# PHILADELPHIA ELECTRIC COMPANY

May 16, 1983

Subject: Limerick Generating Station, Units 1 and 2  
Request for Information from the Radiological  
Assessment Branch

The attached documents are draft question response changes and draft text changes to the FSAR resulting from the discussions with Mr. Mike La Mastra, Radiological Assessment Branch reviewer, at the referenced conference call.

TABLE 5

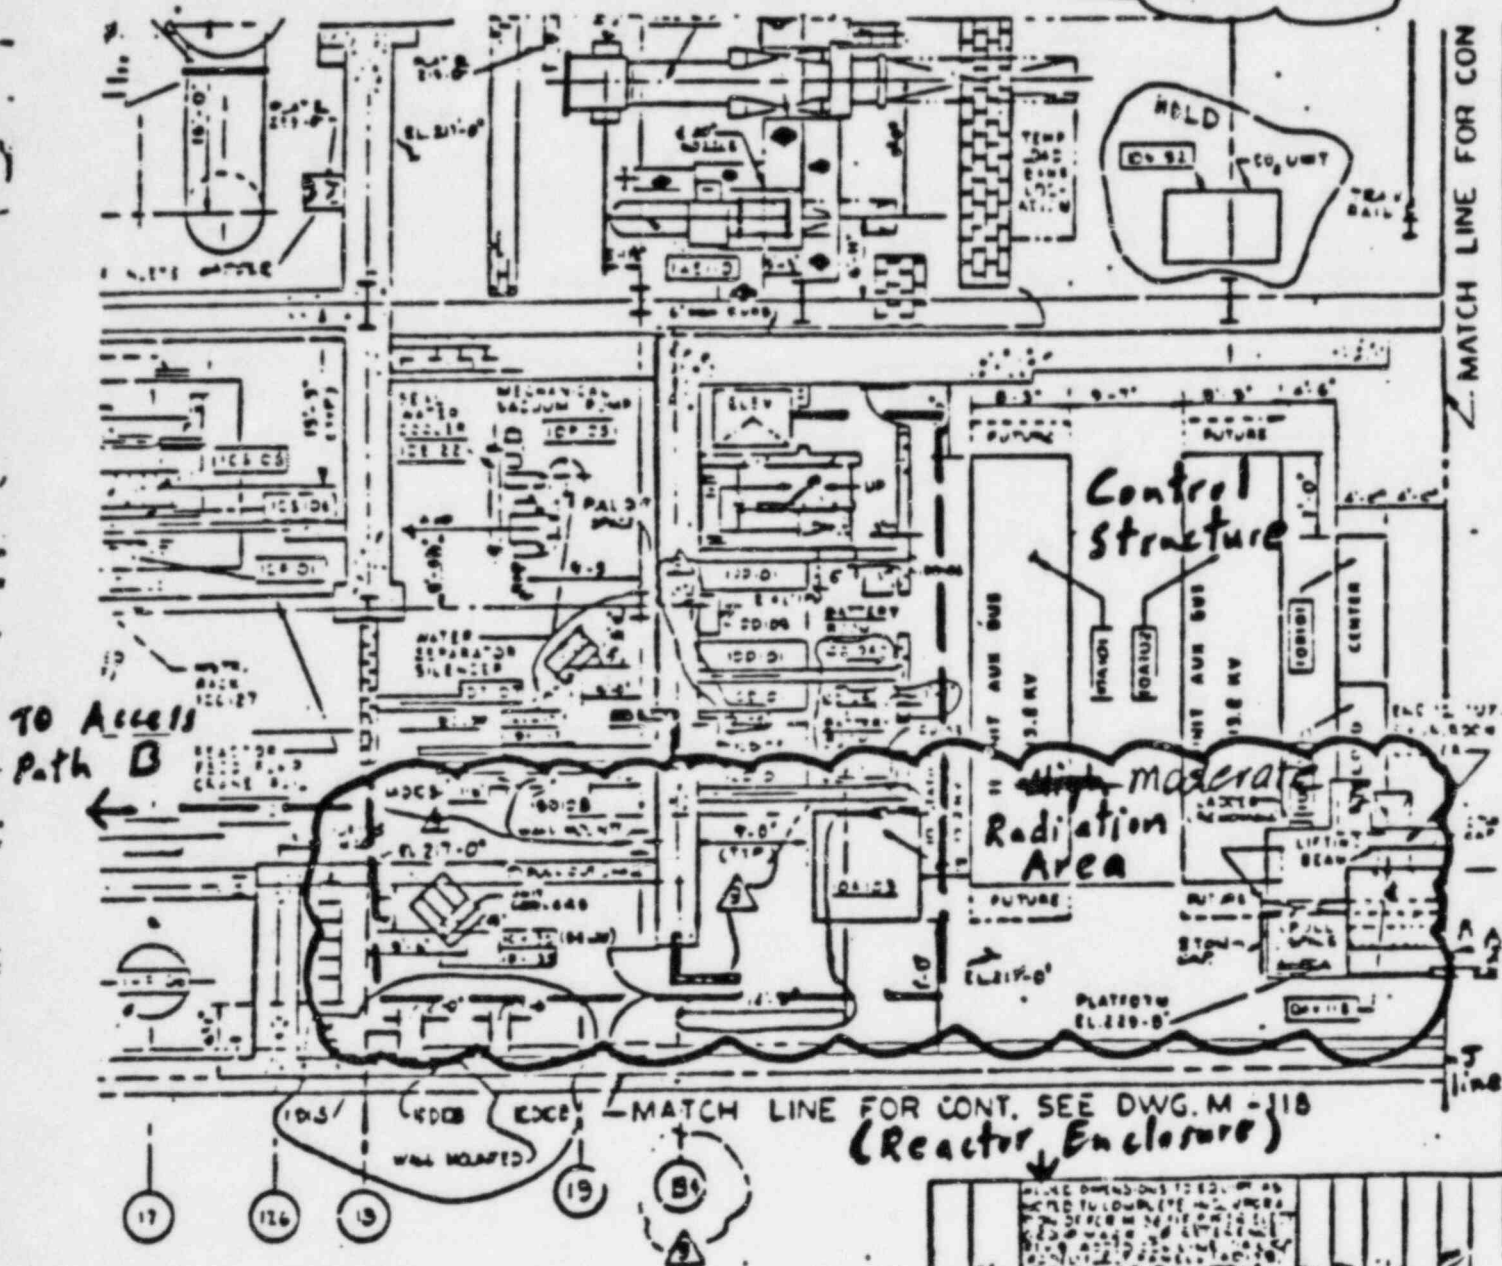
Potential Problem Area(1)	Solution	Remarks
<del>Main Control Room</del>	<del>Additional piping to the control room and the turbine enclosure.</del>	<del>Shielding for main control room should be such that control room dose is sufficient to meet treatment of piping.</del>
<del>Waste Control Room</del>	<del>Restrict access to this area. Personnel should be kept out of this area for about 2 hours only.</del>	<del>This restriction should not cause a problem for operators. Access to this area is required only when a trouble is taken outside the control room in the vicinity of a problem in the waste disposal system. Access to the waste disposal system should be restricted to personnel only. When this restriction is in effect, which could be accomplished in a short period of time.</del>
Access Path <del>to B</del>	An alternate path should be used until the dose rate falls below 10 mads/hr in the vicinity of access path <del>to B</del> .	Using Figure 1.13-2, it can be seen for access path <del>to B</del> that the dose rate for access path <del>to B</del> will fall below 10 mads/hr in less than 2 hours after a DVA. Access path <del>to B</del> would be used for access to the radioactive control room, radiochemical laboratory, or counting area from the control room.

about 2 hours after a CAN  
 It access is required before the dose rates for access path ~~to B~~ have fallen to acceptable levels, the

(1) ~~main control room is shown in Figure 1.13-2 and 1.13-4. The ~~main~~ <sup>access</sup> path ~~to B~~ is shown in Figure 1.13-1.~~  
 IS IS

**FIGURE 1.13-1** Sheet 2 of 3

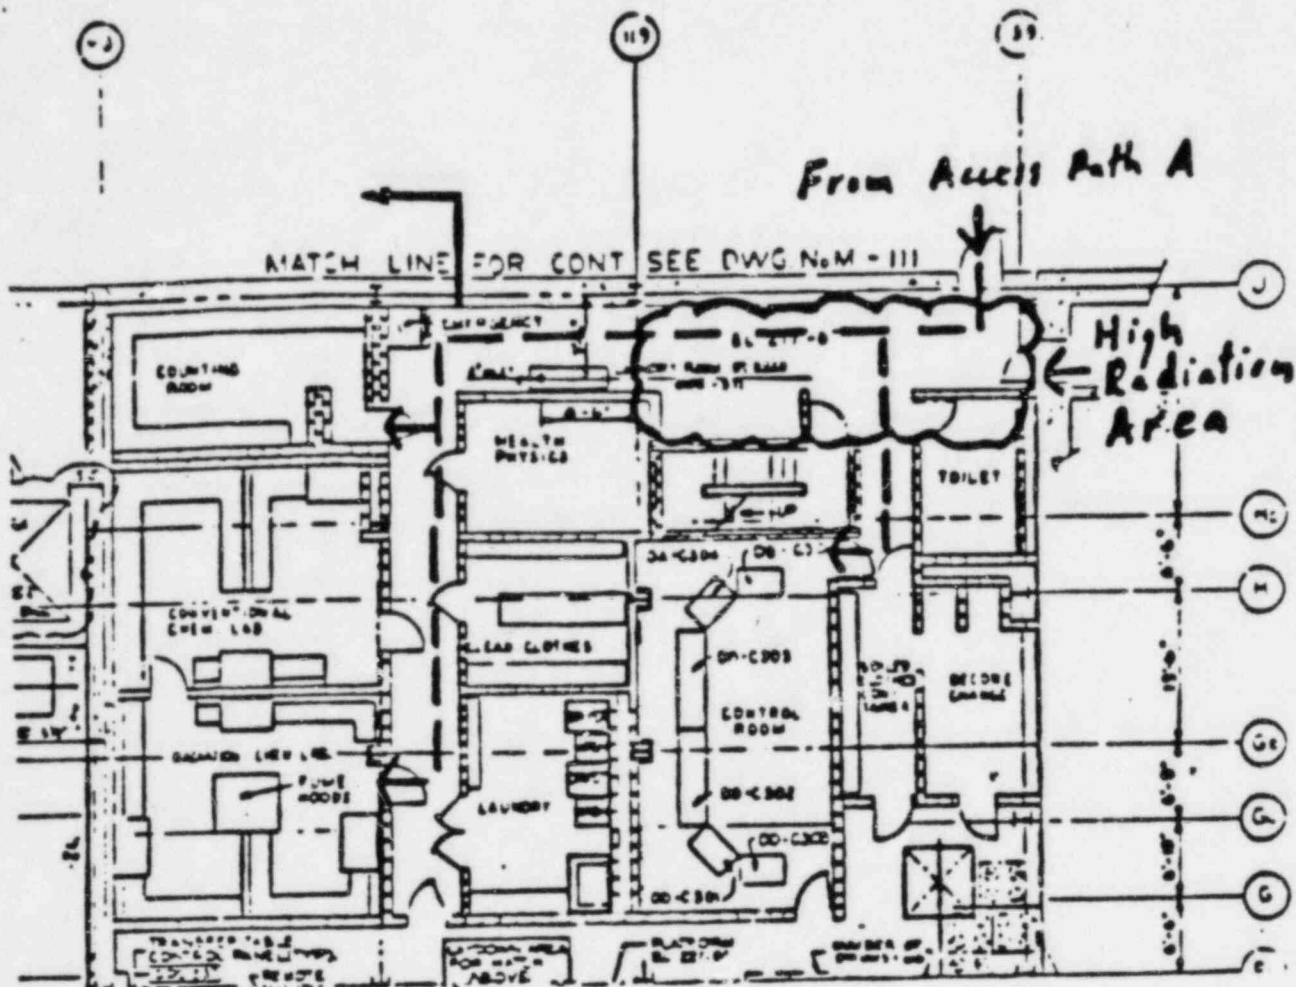
See Note on sheet 1 of 3  
 Note: The layout of this area will be revised per PLO-11443, dated 9/26/80. However, the layout revision will not affect the designation of the high radiation area shown on this figure.

FIGURE 1.13-2

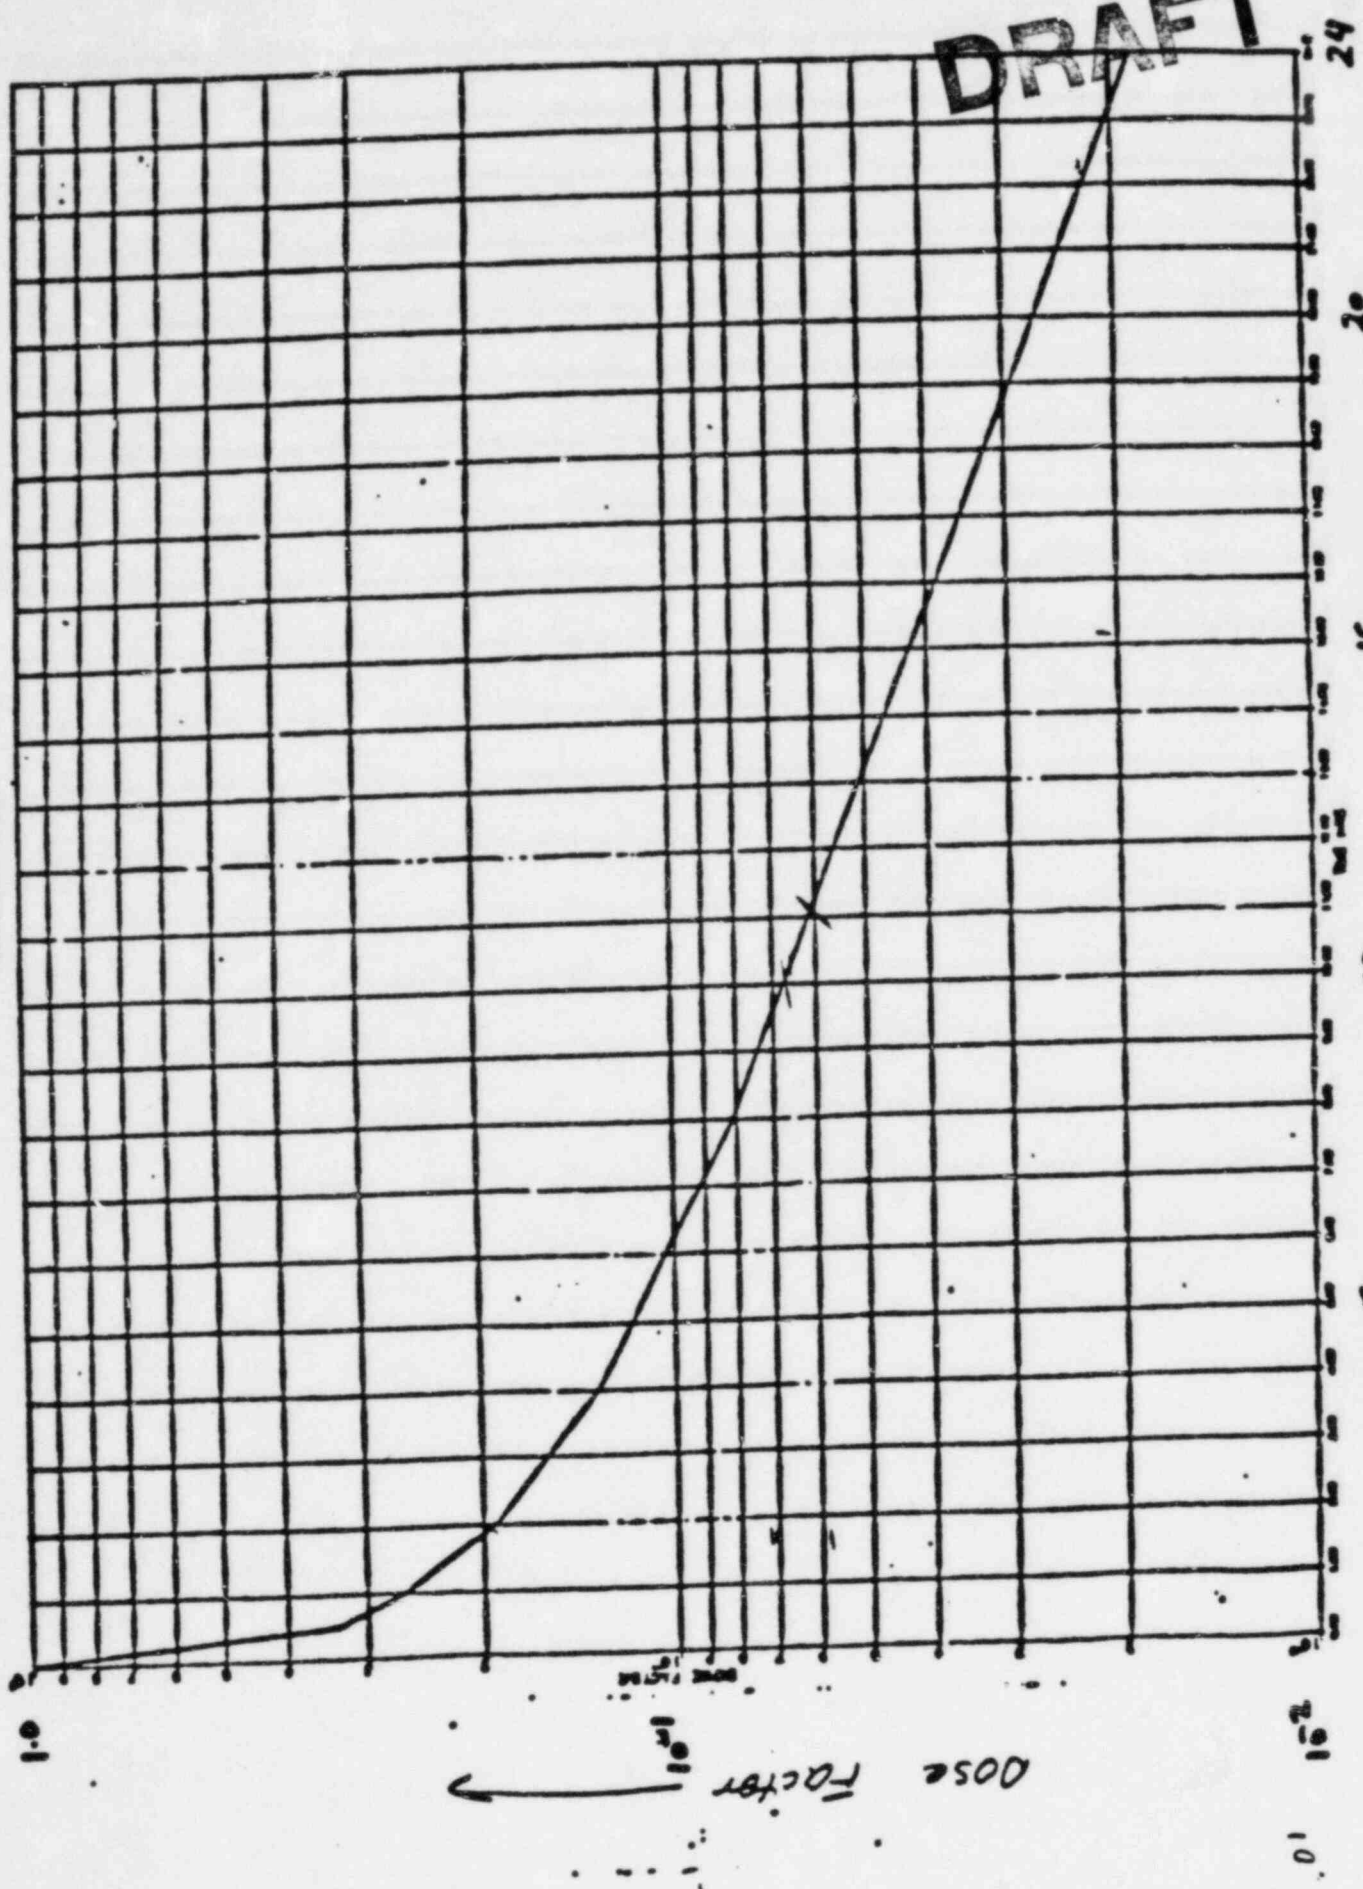
- 4 Peak shine dose rates are provided in Tables 1.13-1 ~~and 1.13-2~~ along with the integrated doses. The dose rate at any given time for a vital area can be estimated by multiplying the peak dose rate by an appropriate factor which can be determined by using the curves in Figures 1.13-2 and 1.13-3.

FIGURE 12.3-16

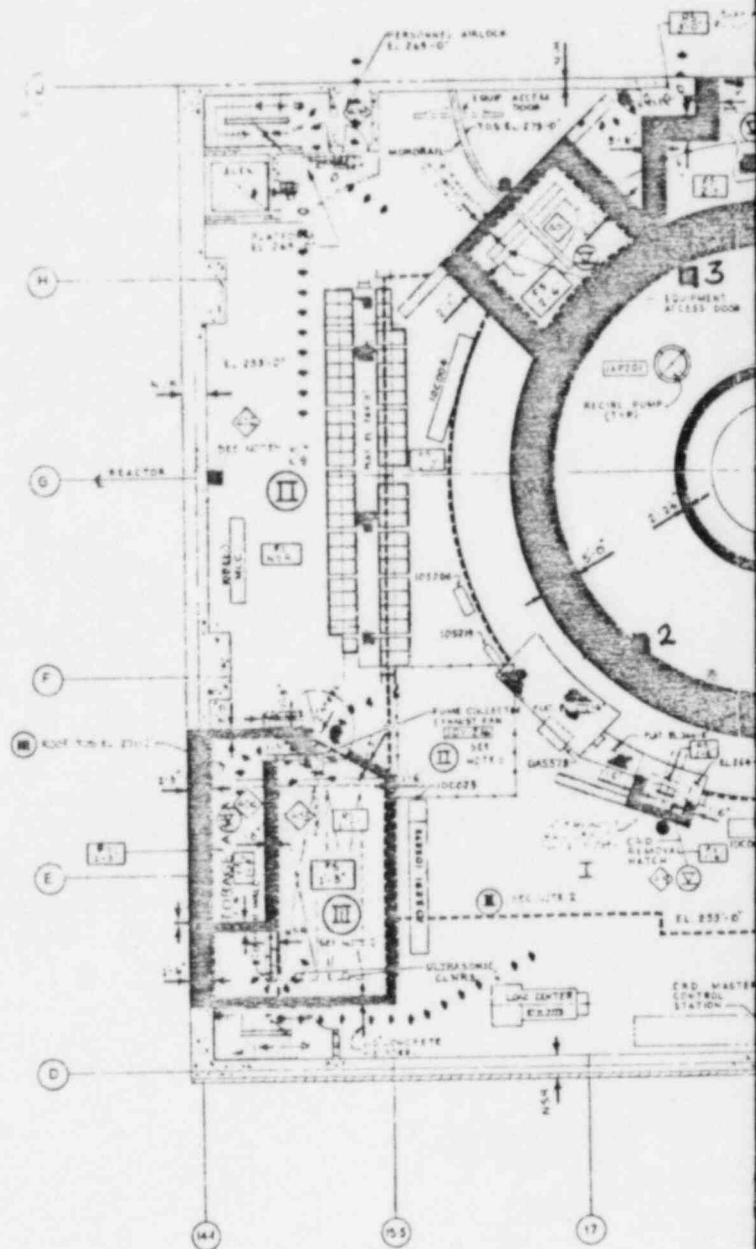
↓ (replace this sentence with the following:) The primary containment post-LOCA radiation monitoring system provides a trip signal to the containment sump pumps on an upscale alarm indication.

THE SENSORS ARE LOCATED IN SEPARATE  
AREA OF CONTAINMENT TO PROVIDE INDE-  
PENDENT MEASUREMENTS AND "VIEW" LARGE

(See Figure 12.3-16 for locations)  
CONSIDERATION TO ACCESSIBILITY FOR MAINTE-  
NANCE AND CALIBRATION WAS GIVEN IN  
THE SELECTION OF THE SENSOR LOCATIONS.
